**UPPER UWCHLAN TOWNSHIP  
PLANNING COMMISSION  
AGENDA  
September 10, 2020  
7:00 p.m.**

| II. Windsor Baptist Church – Final Land Development Plan<br>Review the Final Land Development Plan and consultants' comments for the @ 8,600 SF building addition to house the Christian Academy.  | 2             |

- Land Development Plan Set titled “Windsor Baptist Church” consisting of twenty (20) sheets, prepared by Ludgate Engineering Corporation, dated January 22, 2019, last revised April 14, 2020.

**LAND DEVELOPMENT PLAN**

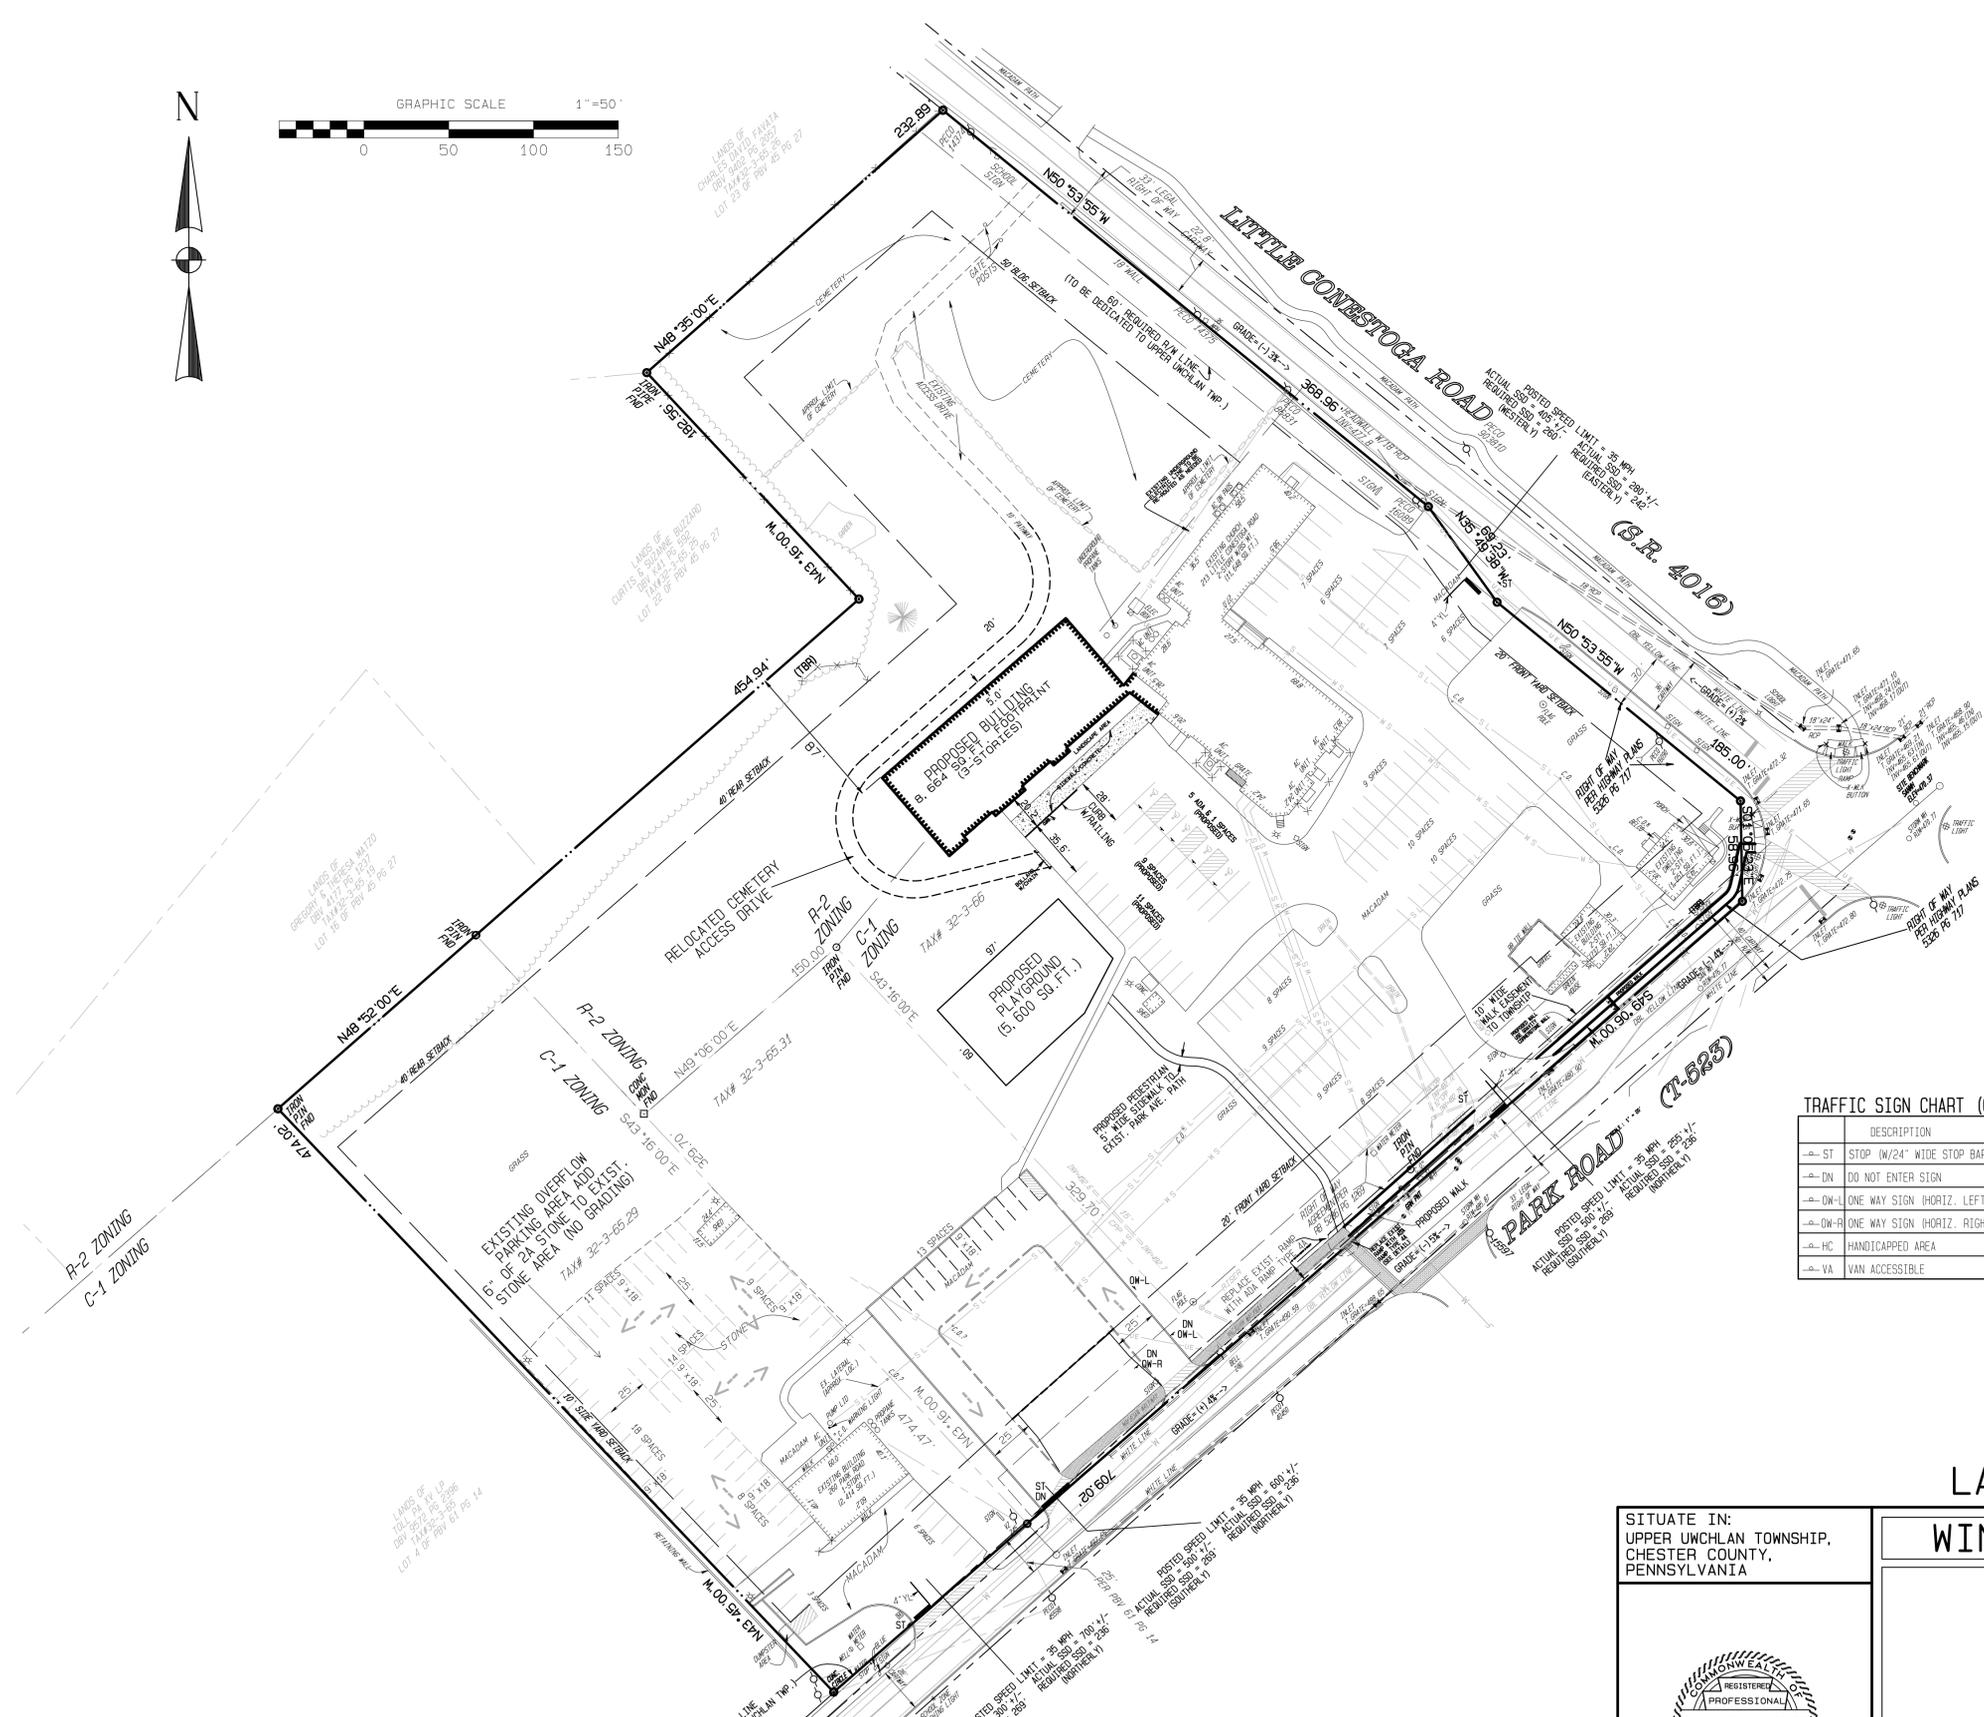
**Please provide all lot lines, lot line bearings and distances for all three individual lots on the Land Development Plan Sheet 2, and the Existing Features Plan Sheet 12. Currently, the labels and lot lines provided are inconsistent between the two sheets, and should be made consistent between each sheet.**

2. **The Traffic Sign Chart (On Site) on the Land Development Plan does not appear to reflect the correct number of proposed handicap ADA signs. It appears there are 5 handicap ADA signs shown in plan.**
3. **Sidewalk is now proposed along Park Road from the Park Road Access to Little Conestoga Road. However, no proposed grading has been shown for the sidewalk or the associated retaining wall. Please provide this information. A larger scale detail might be appropriate.**

**SIDEWALK DETAIL**  
SCALE: 1" = 20'

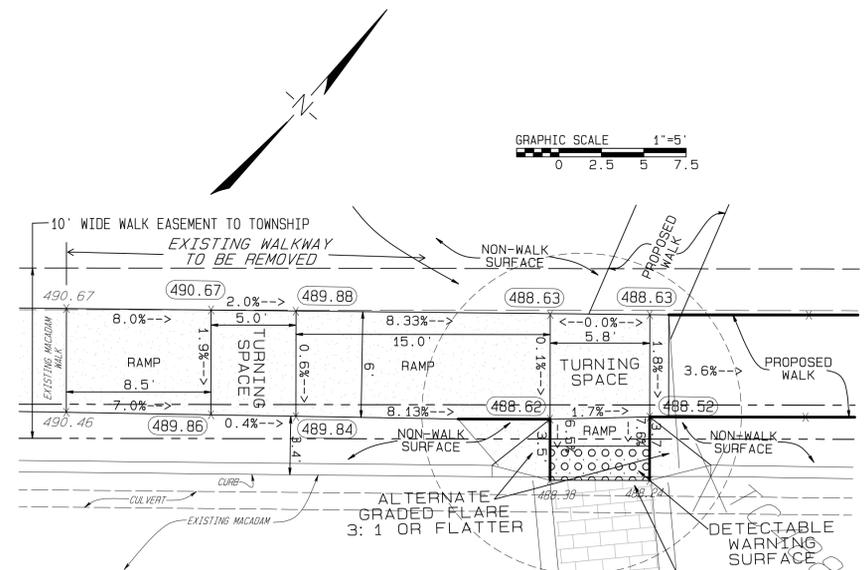
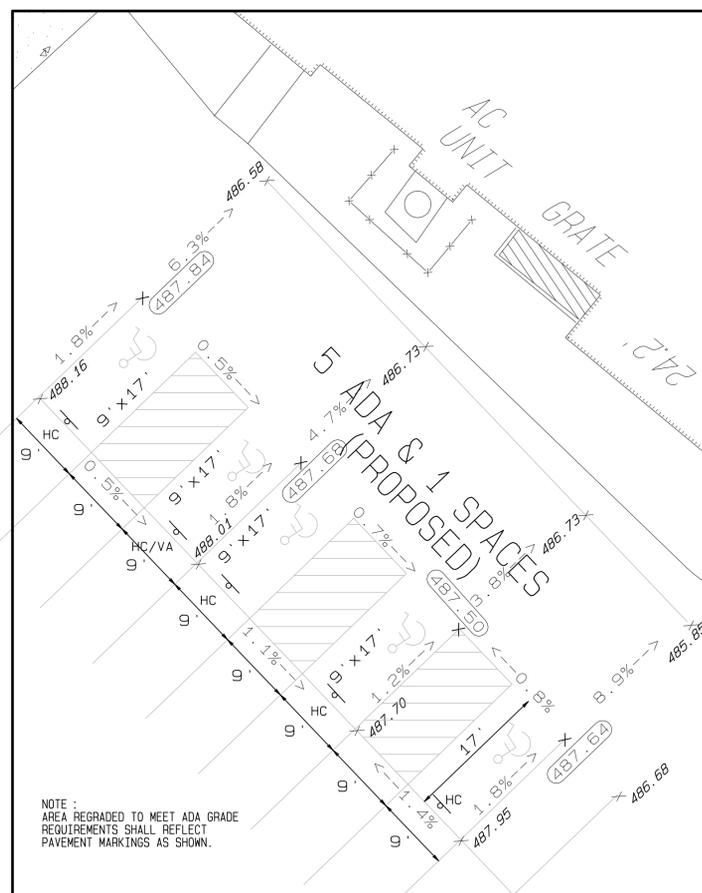
- c) Subbase 4.0-inch depth (No. 2A)
3. The sidewalk detail on sheet 8 appears to show a continental crosswalk across the easternmost Park Road driveway. Alternatively, we would also support conventional crosswalk of two six-inch white lines as a lower cost and lower maintenance option at this driveway and the other driveways when appropriate. The plans should show PennDOT’s typical striping detail for either option, and the proposed stop bar should be located four feet in advance of the crosswalk. In addition, all proposed pavement striping should be clearly noted on the plan view on sheet 2.

4. ADA compliant curb ramps should be provided for pedestrians crossing the easternmost Park Road driveway. Please provide detailed designs of these curb ramps on sheet 8.

5. The following comments pertain to the sidewalk detail provided on sheet 8.
  - a) Additional grading detail should be provided where the asphalt path connects to the existing curb ramps on the northwest corner of the Little Conestoga Road/Park Road intersection to determine whether a five-foot by five-foot turning area is provided. Please note that if an ADA compliant landing area is not provided in this area, the proposed 8.2% grade of the path just west of the Little Conestoga Road/Park Road northwest corner ramps must be revised to be a maximum of 5.0%.

- b) Please investigate whether the existing concrete retaining wall behind the existing curb ramps on the northwest corner of the Little Conestoga Road/Park Road intersection should be reconstructed to accommodate the new pedestrian path, and provide additional information resulting from the investigation.

**LANDSCAPING PLAN**

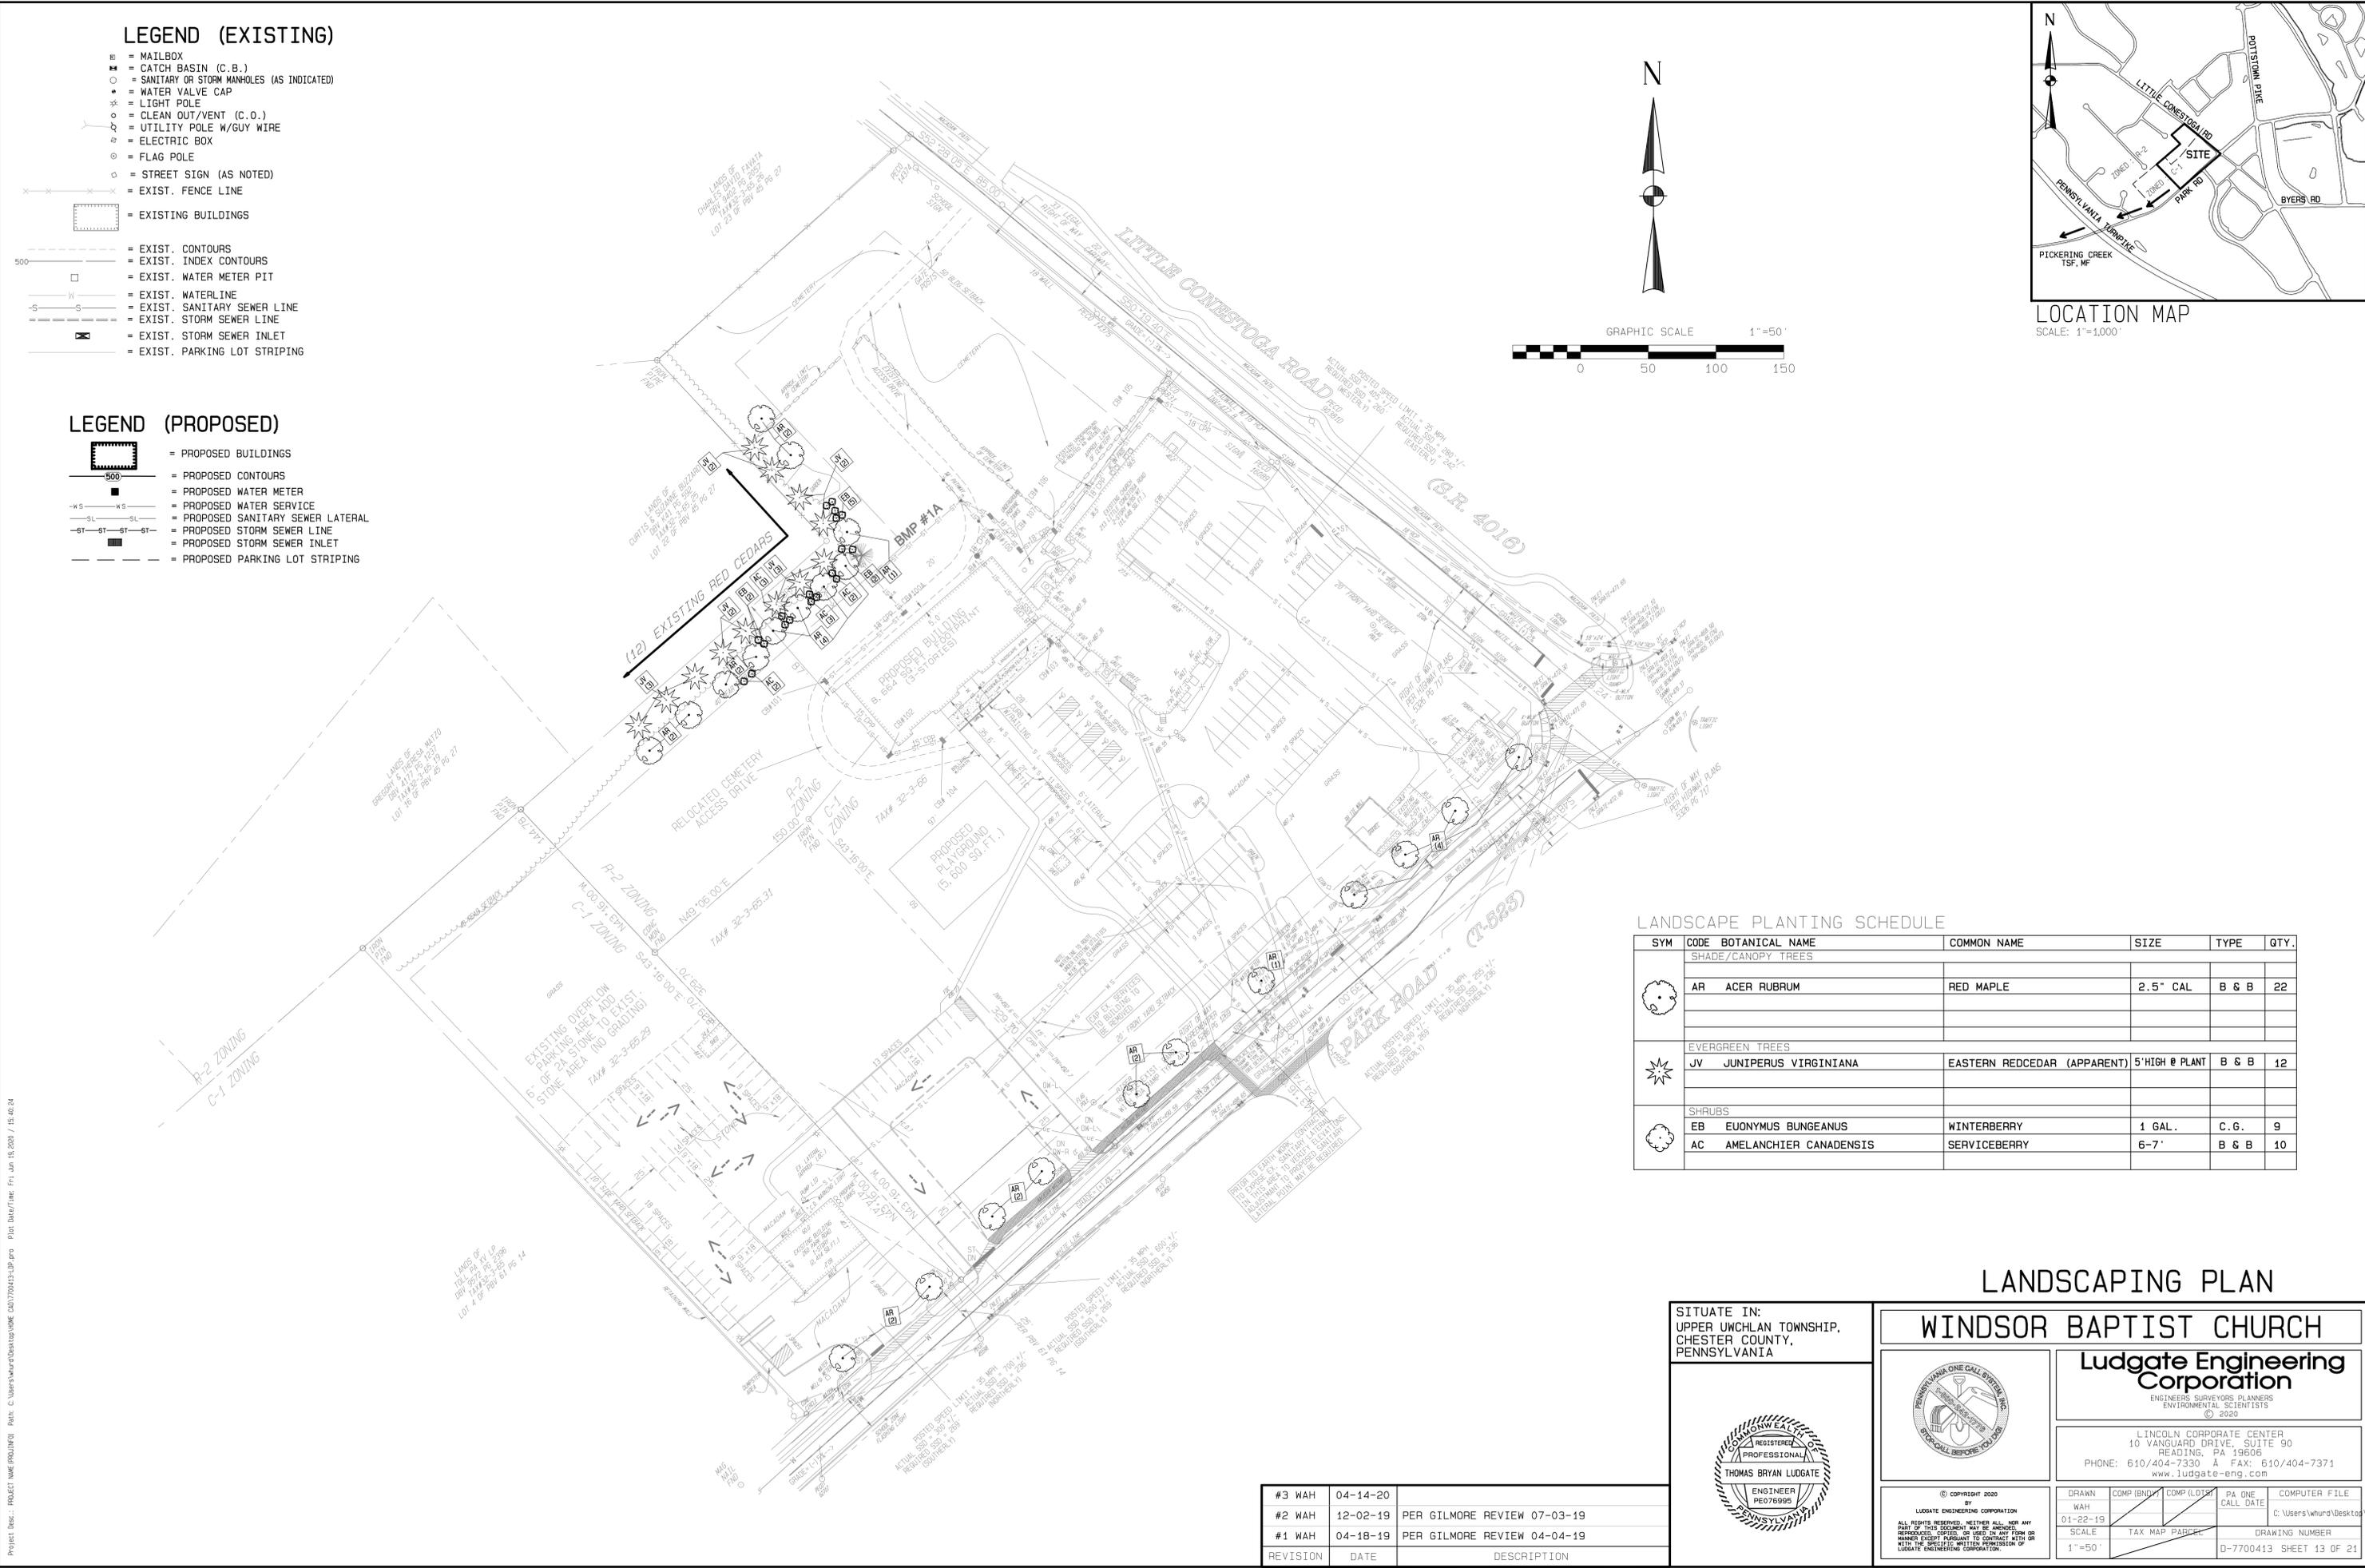
ZO 200-77.B(1)(a) states the planting strip shall include a variety of evergreen species, not exceeding three and SALDO, section 162-57.C(5)(a) states evergreen plantings in screenings shall be “at least seven to eight feet in height.” One type of evergreen is listed on the landscape planting schedule, at five feet in height at time of planting. We recommend the Township request the Applicant to update the landscaping plan to include more than one type of evergreen and at least seven to eight feet in height.

**STORM WATER BMP #1A  
PLAN & DETAILS**

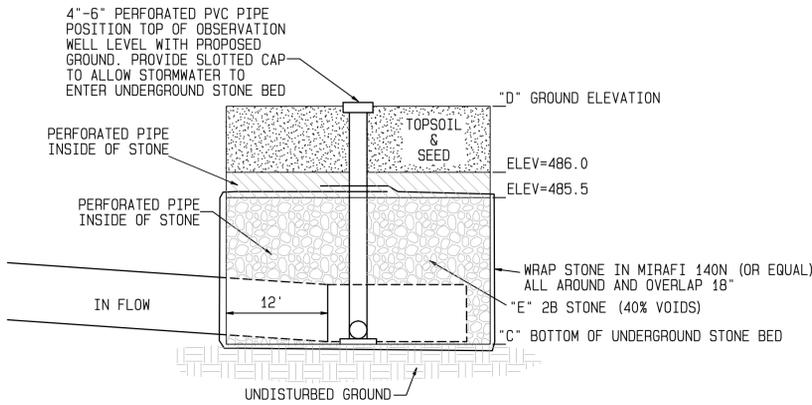
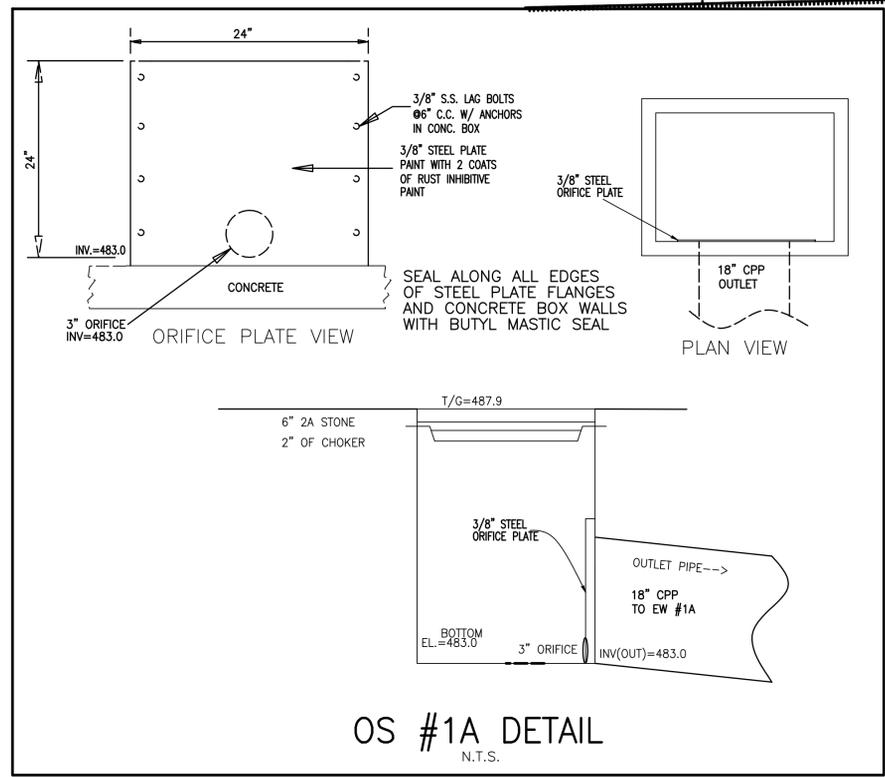
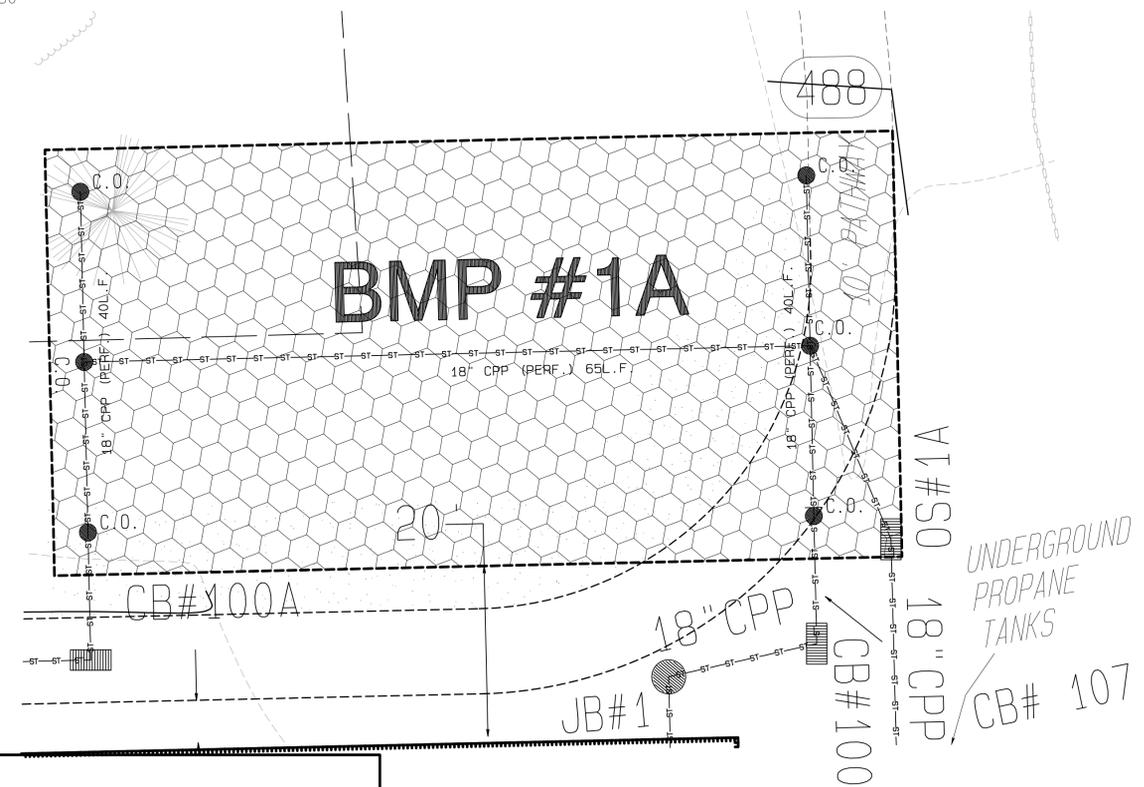
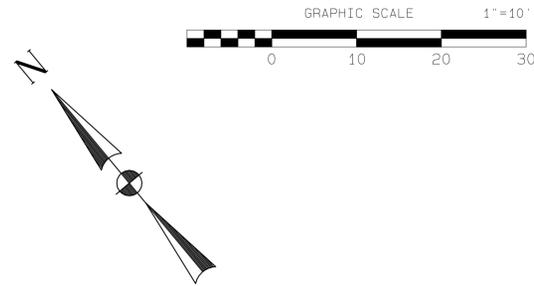
4. The size of the middle cleanouts within the infiltration bed to connect three 18" pipes shall be clarified on the plans. It is unclear if these cleanouts are 4"-6" at the surface or down into the bed, which would be very difficult to connect three 18" pipes together at these locations.
5. Please clarify what the duplicate or erroneous drainage area lines shown on the Pre-Construction Drainage Area Plan Sheet 17 are for. These lines do not match the 0.90 acres Limit of Disturbance lines shown on the Post-Construction Drainage Area Plan Sheet 18.

4. **There is no proposed grading provided for the proposed path connecting the existing macadam walkway along Park Road with the internal walking path. Please provide this detail.**
5. **Provide a revision block on Stormwater BMP #1A Plan & Details Sheet 16.**
6. **Revise the callouts for “Perforated Pipe Inside of Stone” pointing to stone in the Underground Stone Bed Detail on Sheet 16.**
